Project Title: Refurbish Elevators and Replace Controls

Solicitation Questions and Answers
for
Refurbish Elevators and Replace Controls
Project: 437-22-101, RFP: 36C26324R0021
12/15/2024

Solicitation Questions and Answers (updated 3-26-2024) for
 Refurbish Elevators and Replace Controls
 Project: 437-22-101, RFP: 36C26324R0021

Drawing Number
A5.30

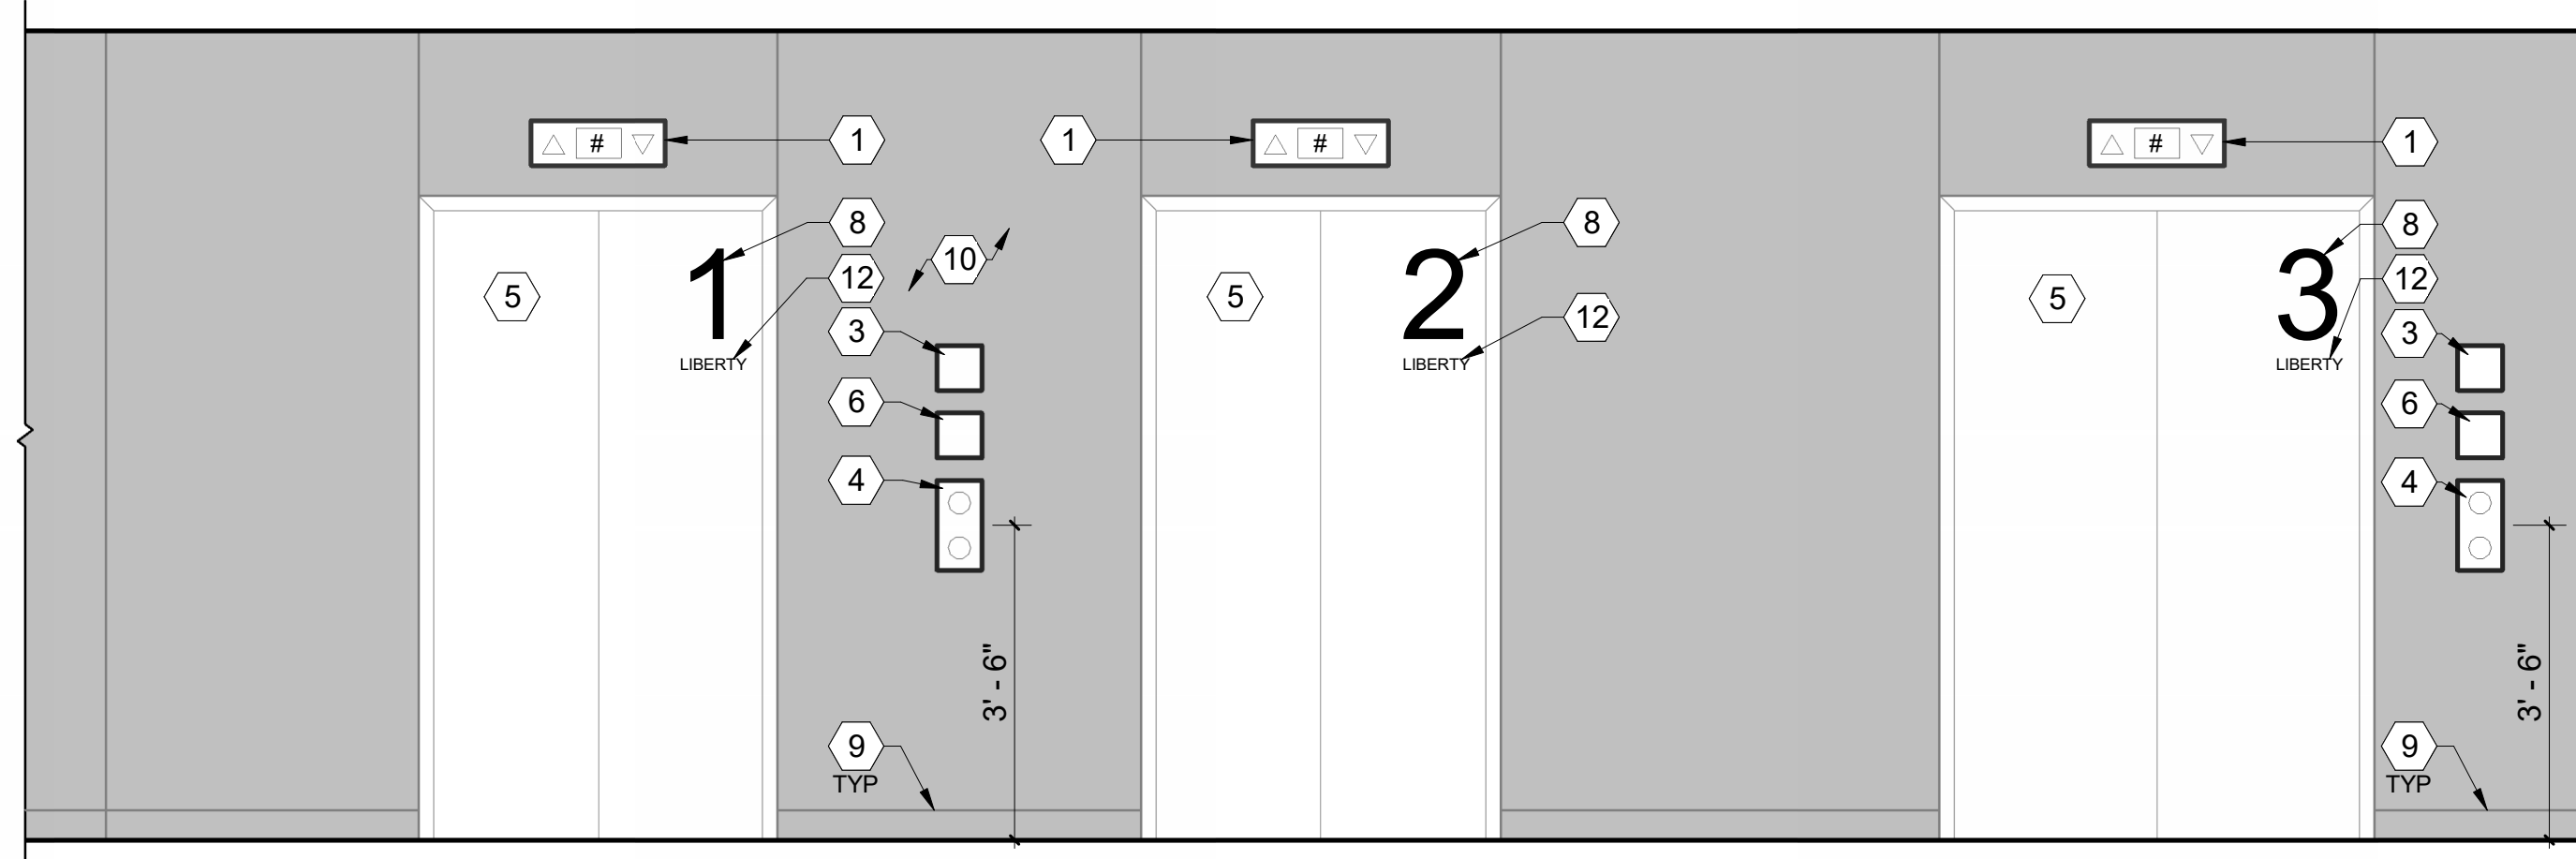
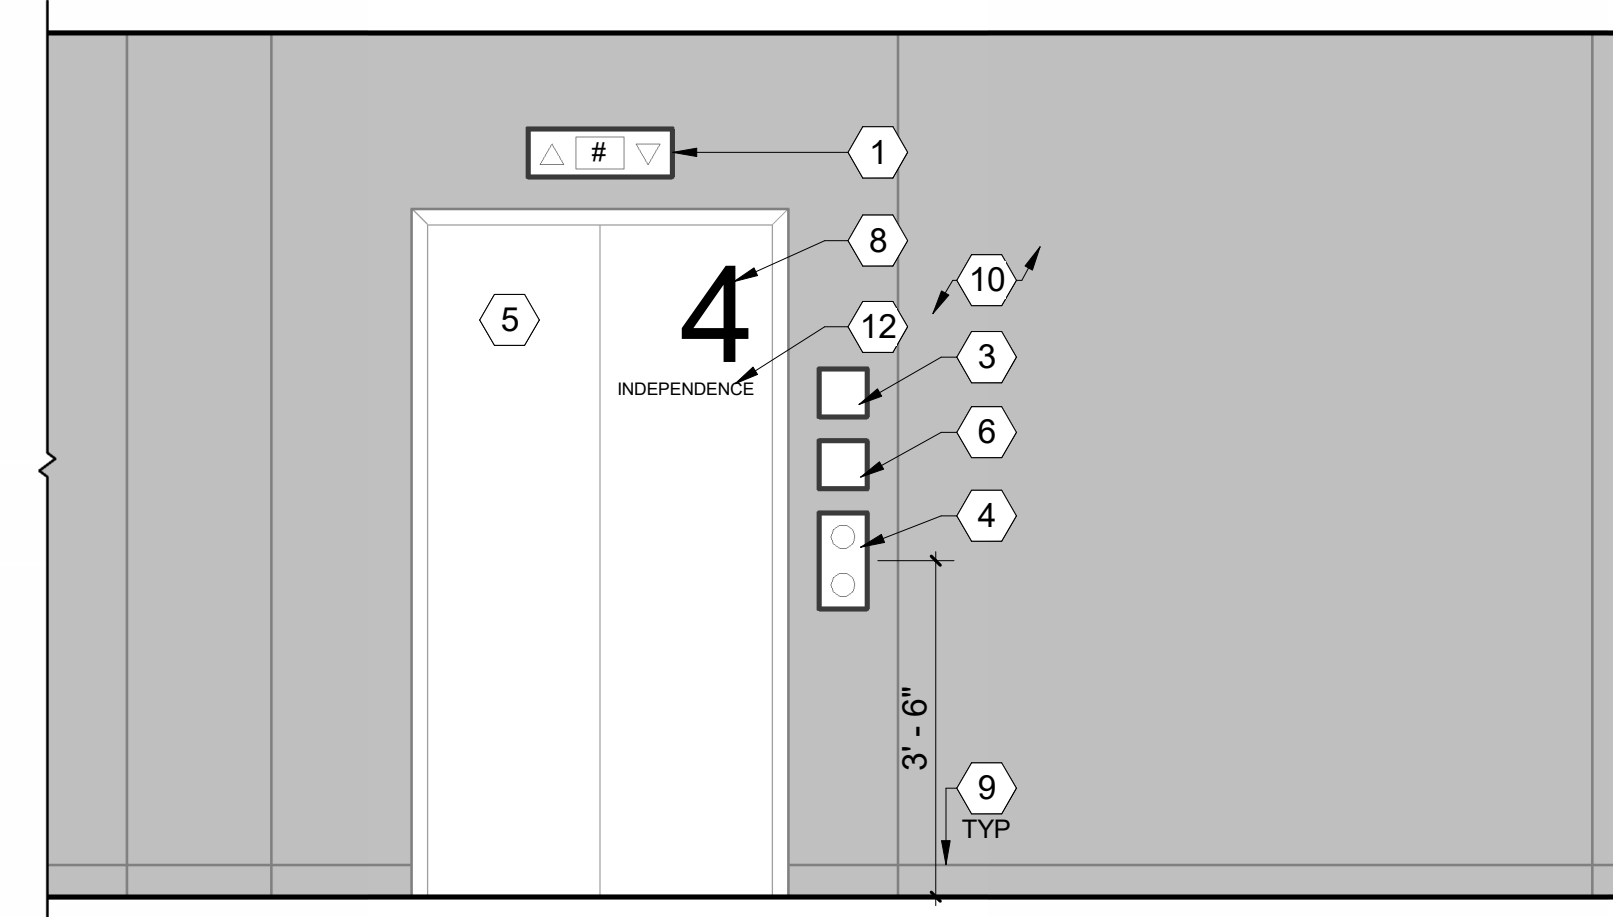
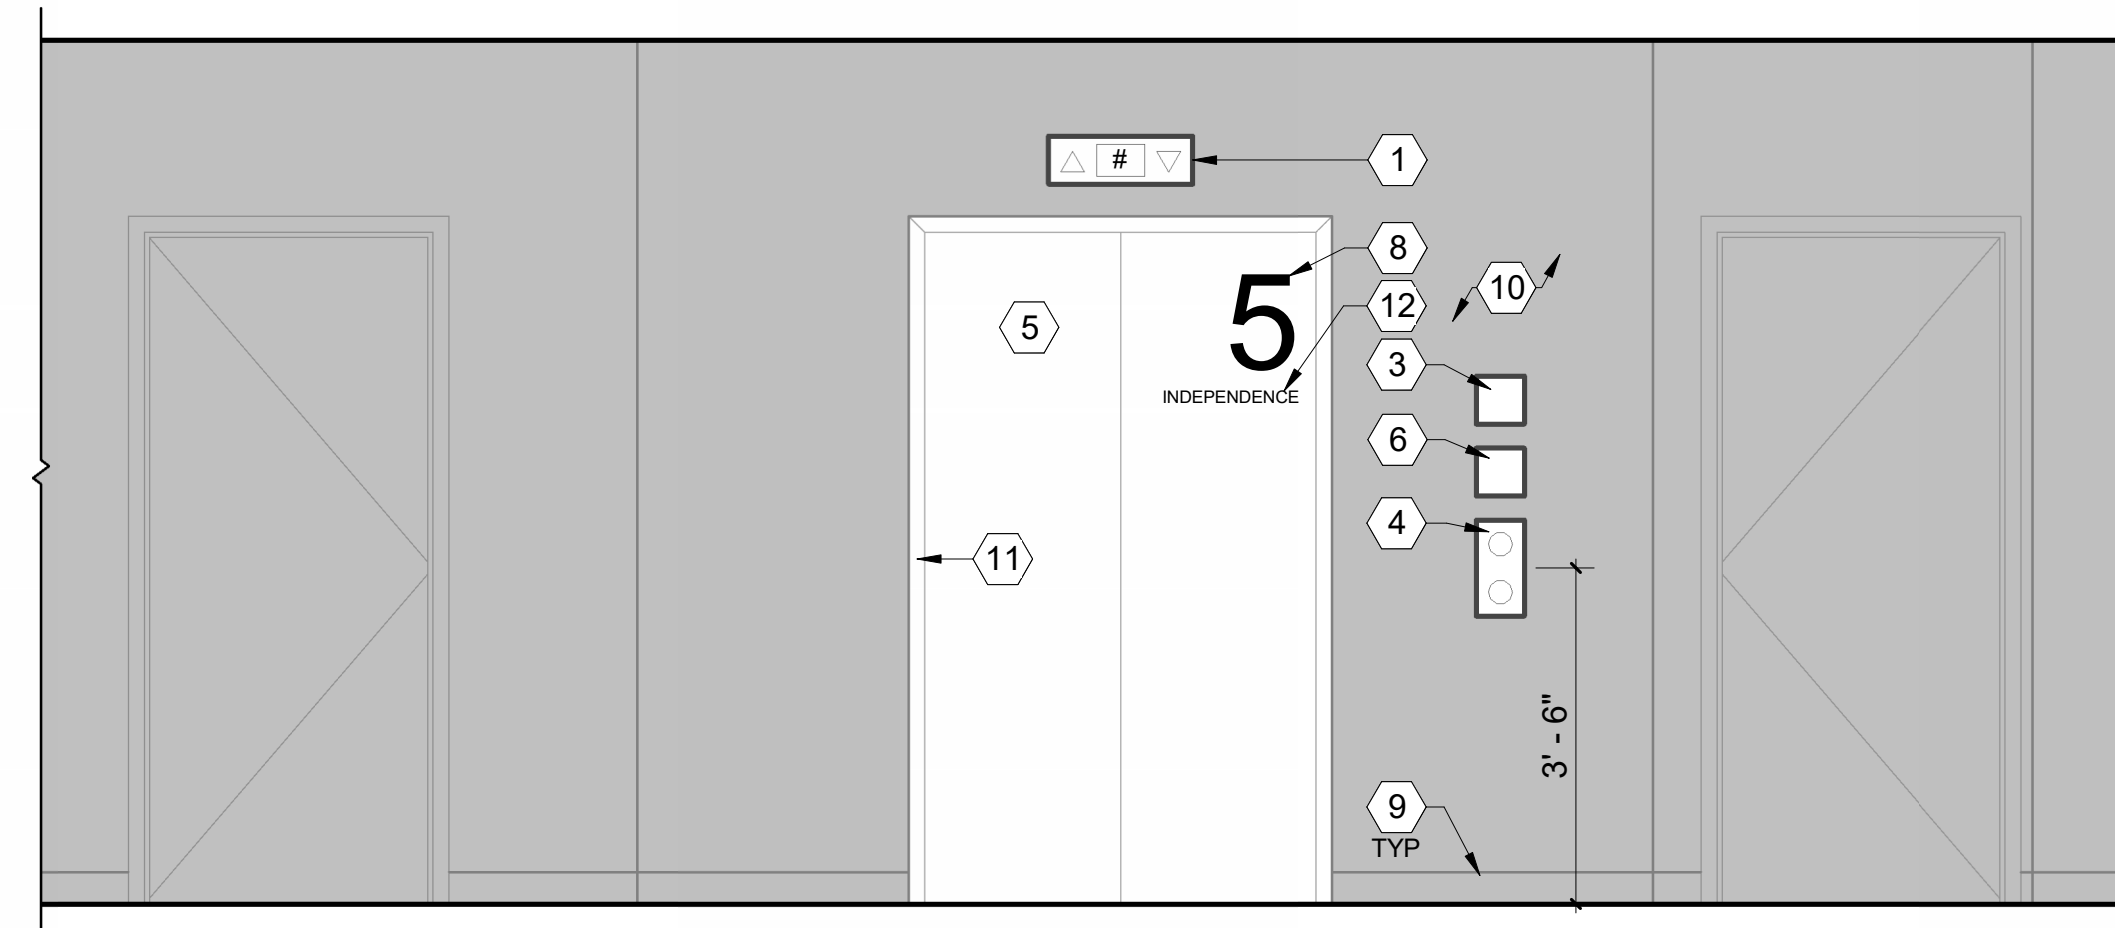
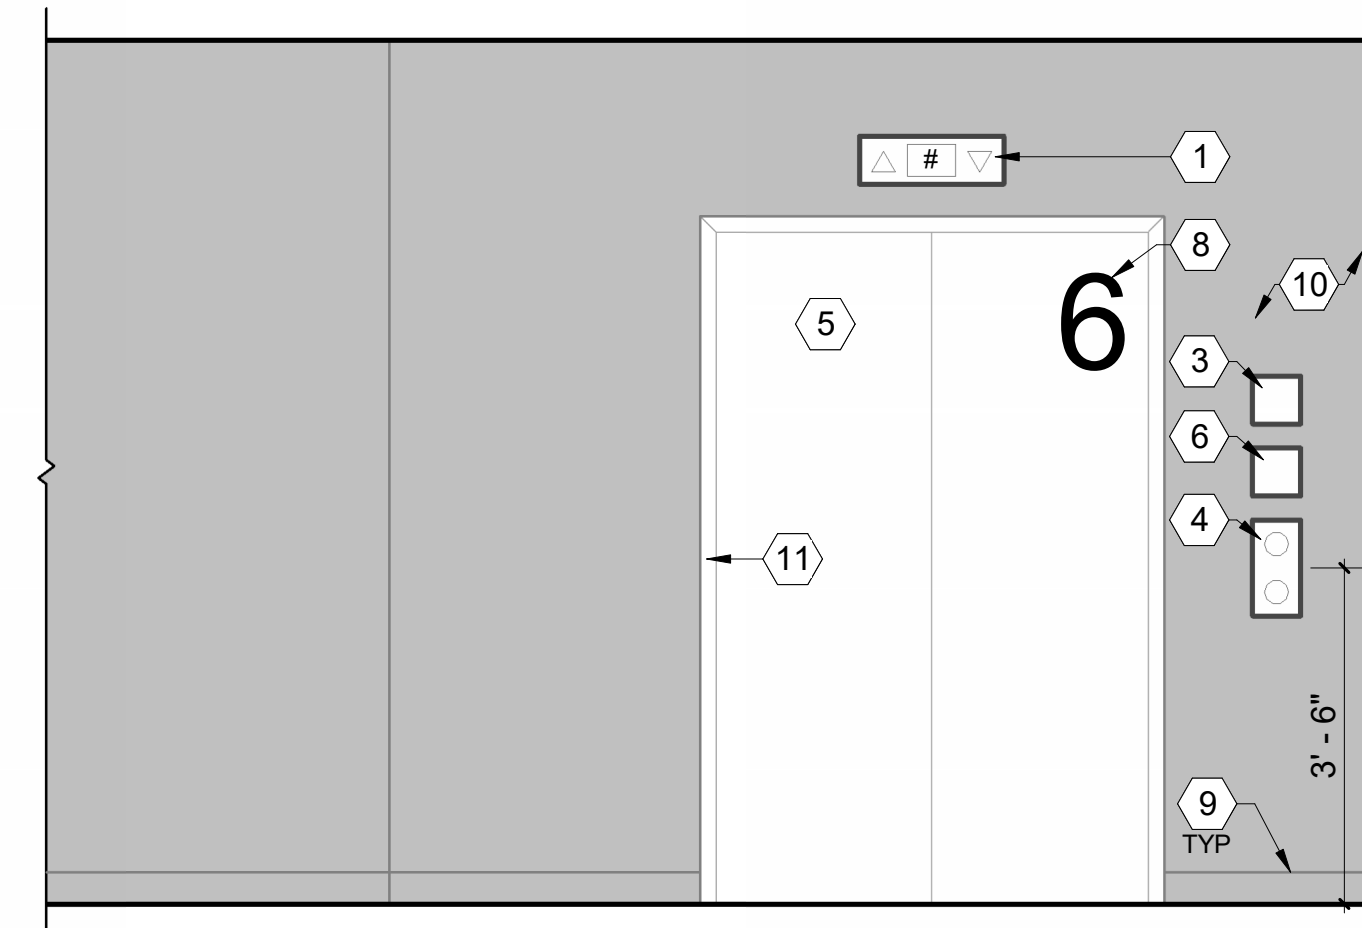
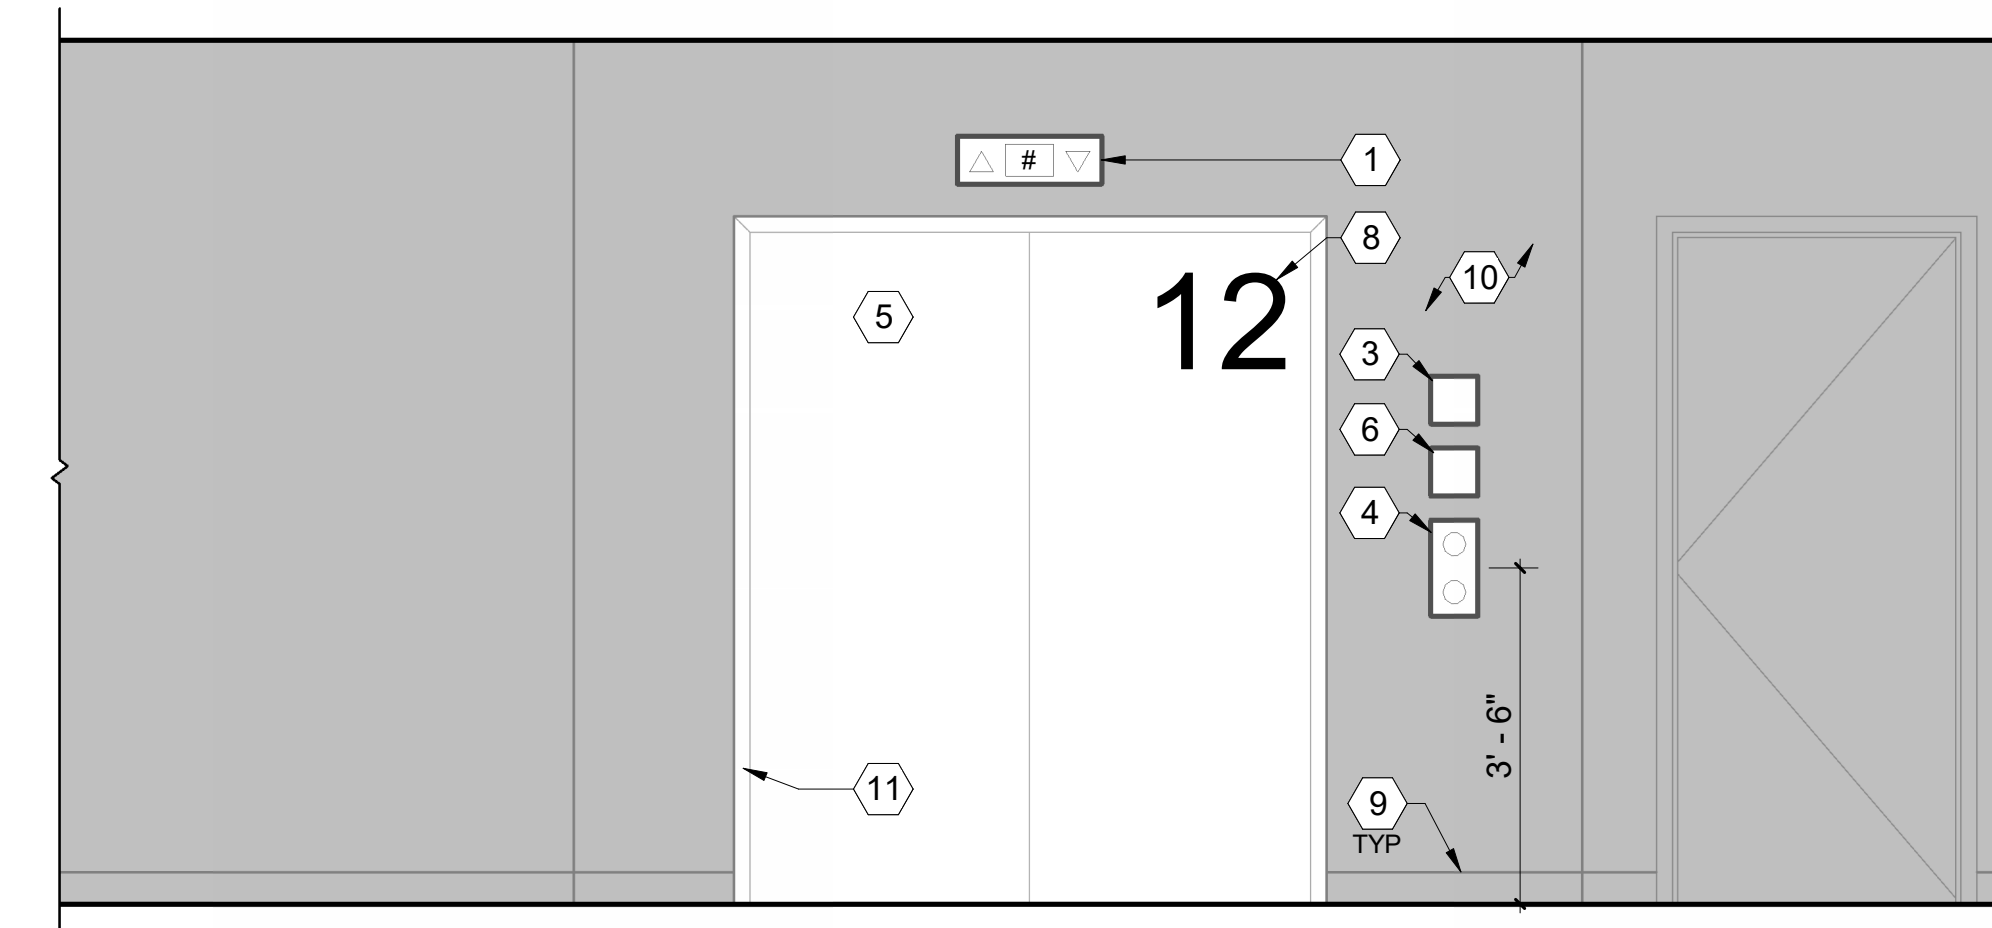
93.	Drawing A5.30 Keynote 10	When wall finishes need to be replaced/repared, will it be acceptable to paint instead of wallpaper, or does VA have leftover stock on wallpaper? If new wallpaper needed, please provide spec of existing.	VA Will provide matching wallcovering stock if they have it available. If matching wall covering is not available, then matching painting will be required.

Drawing Sheet A5.30 INTERIOR ELEVATIONS - LOBBIES – See revised drawing sheet for the adjustment of keynotes # 11.
